CITY OF ALBUQUERQUE

RE: 9050 Alameda Blvd NE
Grading and Drainage Plan Stamp Date: 2/20/19
Drainage Report Stamp Date: 2/20/19
Hydrology File: C20D077

DRAINAGE REPORT
FOR
LOT 16, BLOCK 4, TRACT 3, UNIT 3
NORTH ALBUQUERQUE ACRES

DRAWING: **RETAINING WALL SECTIONS AND GENERAL STRUCTURAL NOTES**

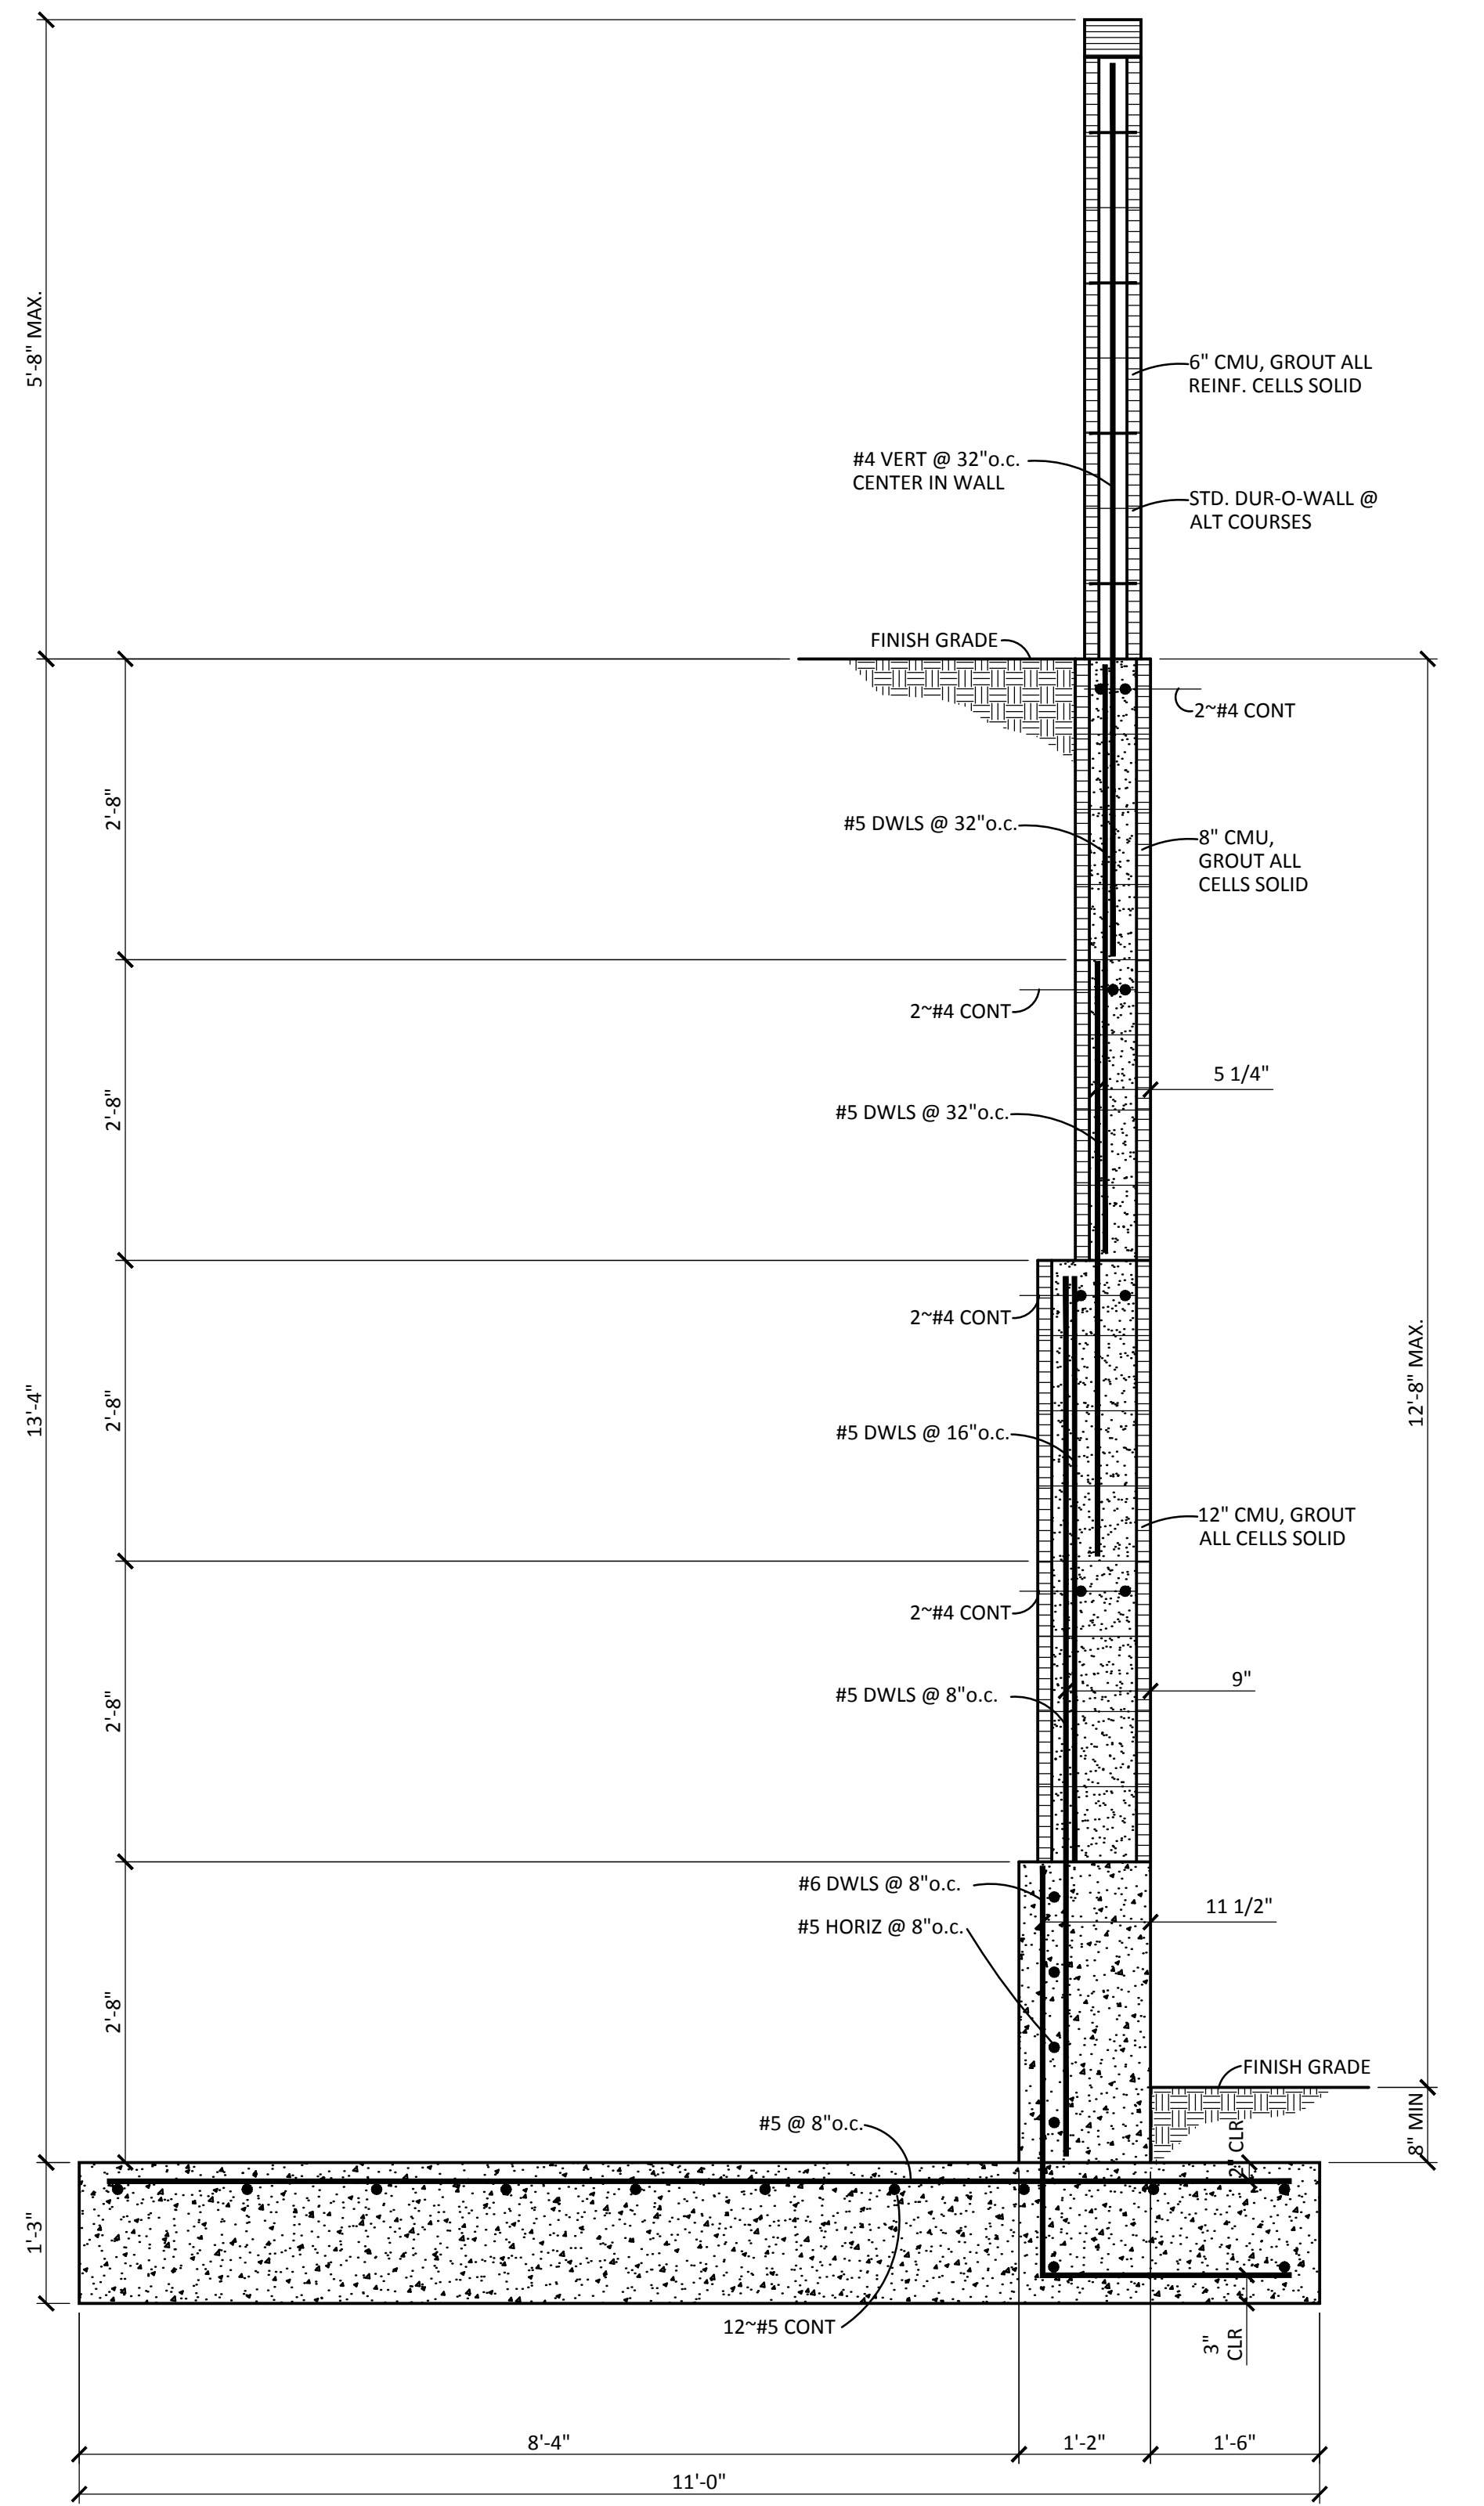
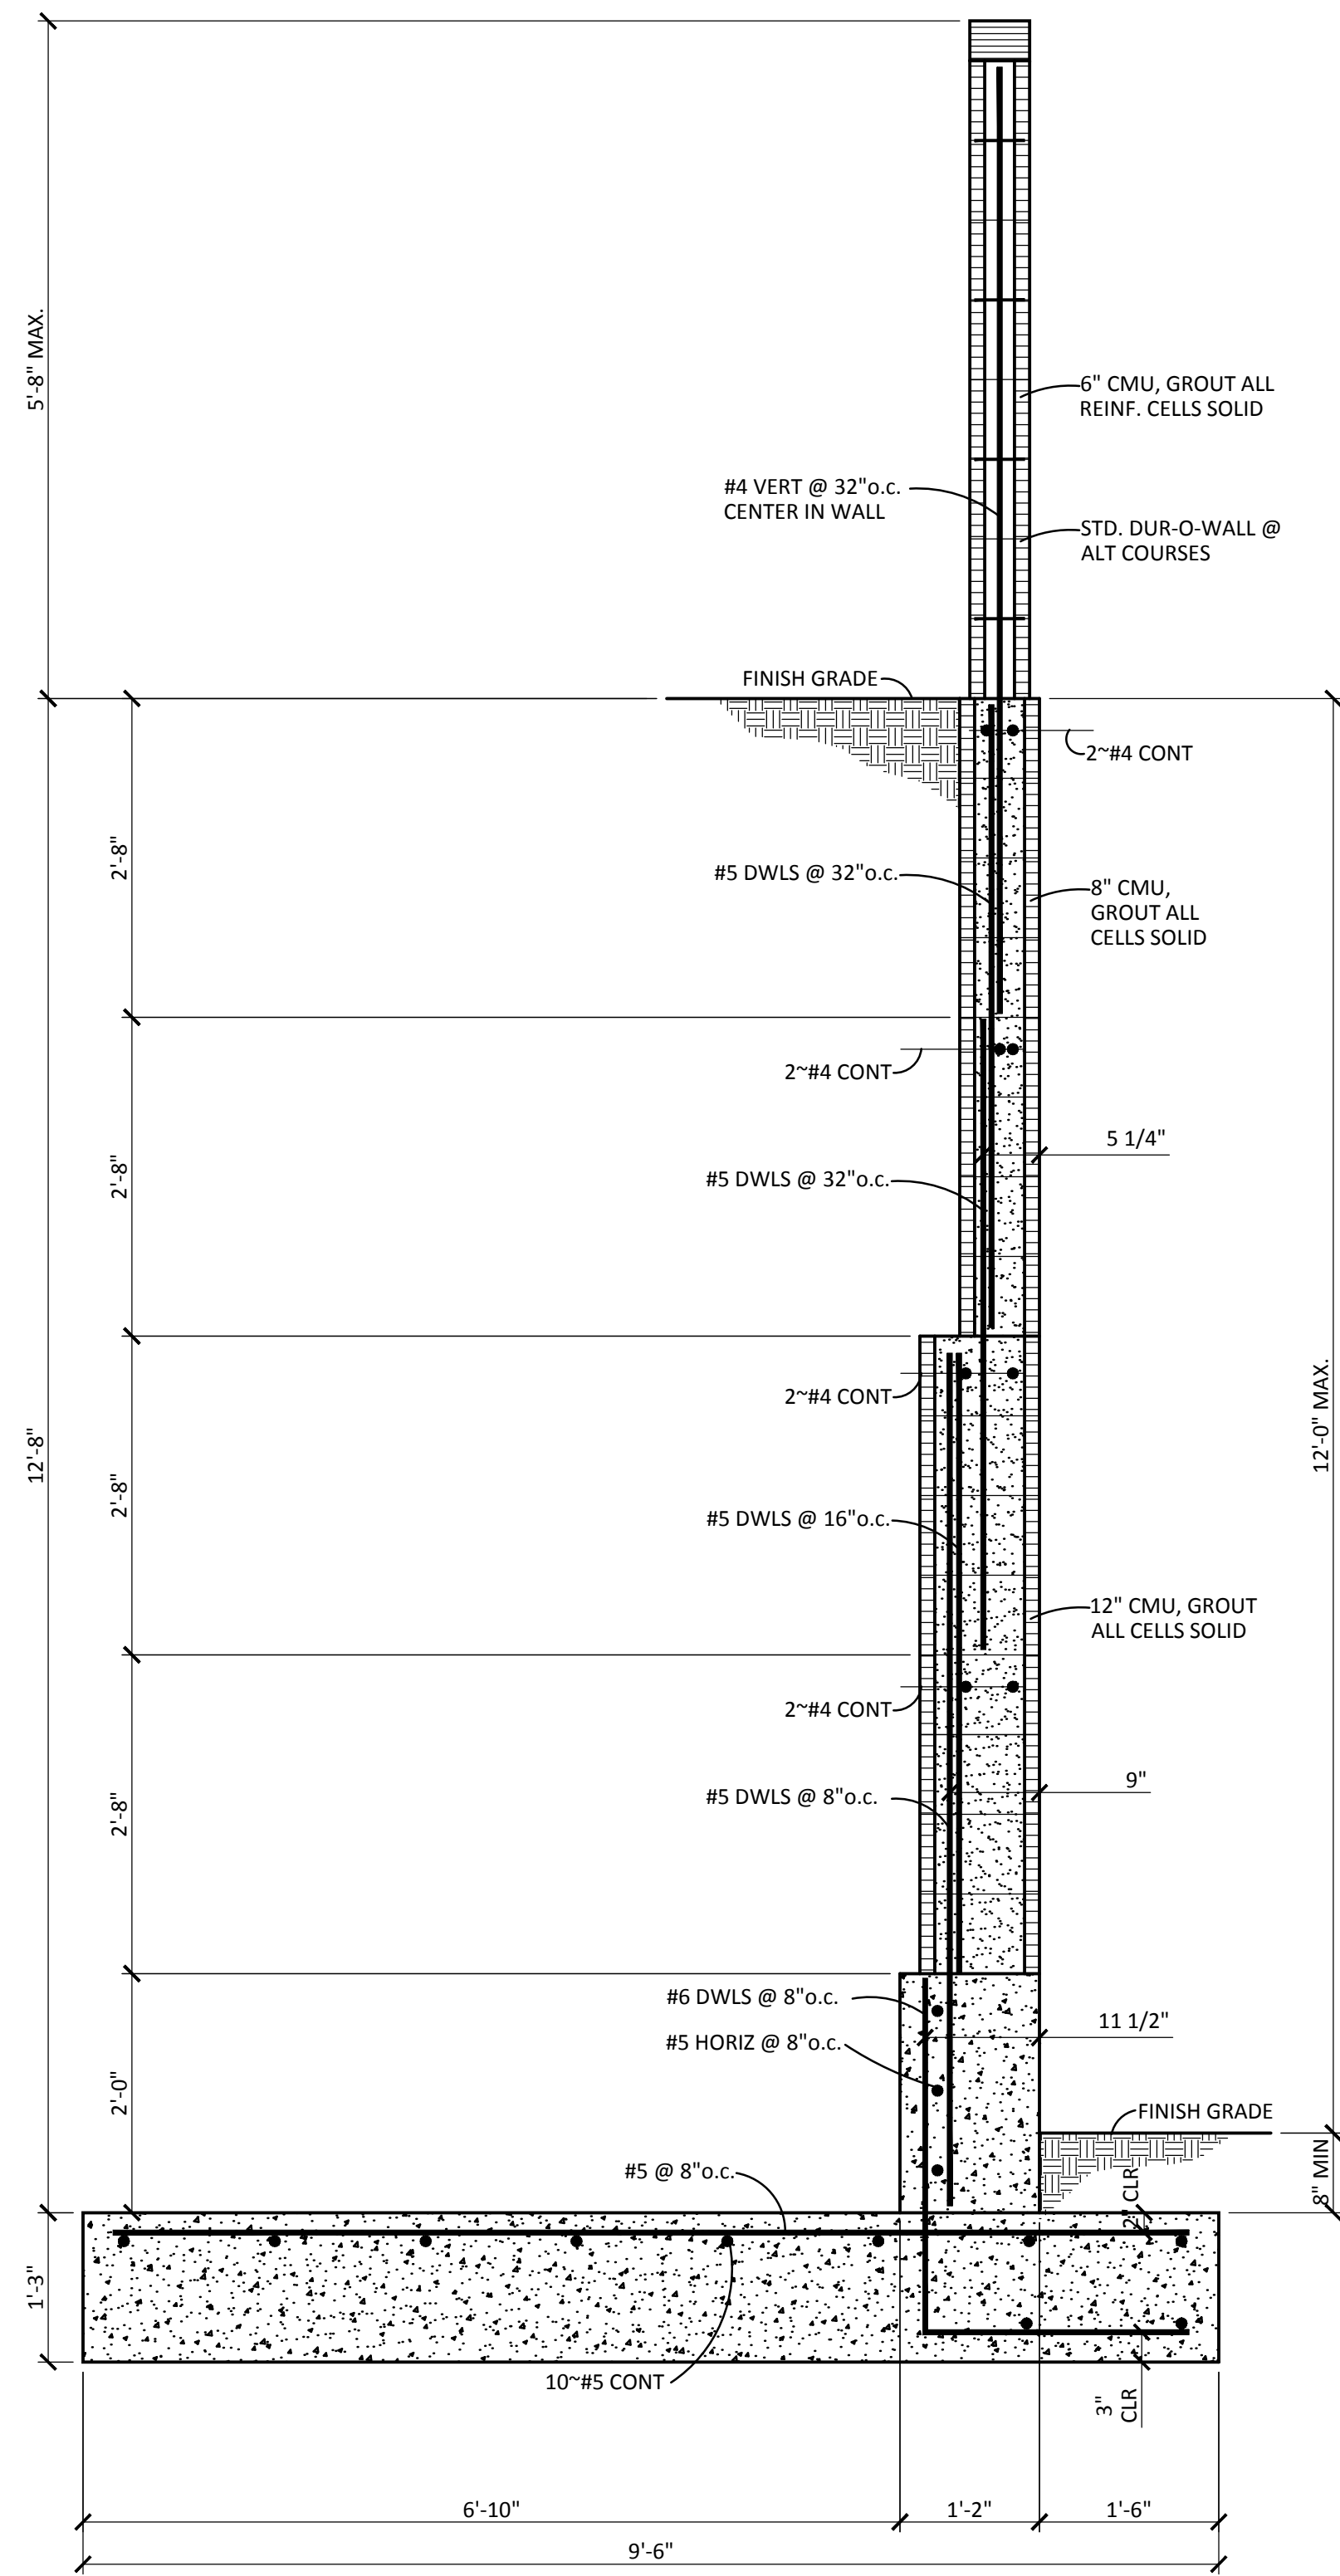
- a. The footing of the scour wall looks too small. The footer has to support the wall after the soil is removed from the low side to the scour depth. Please provide structural calculations including loading assumptions stamped by a registered professional engineer to accompany the wall details shown on the G&D sheets.

- b. The retaining wall details on sheets S1 and S2 don't contain the information requested in this comment, specifically the easement and property lines. There is also no indication where each section applies.
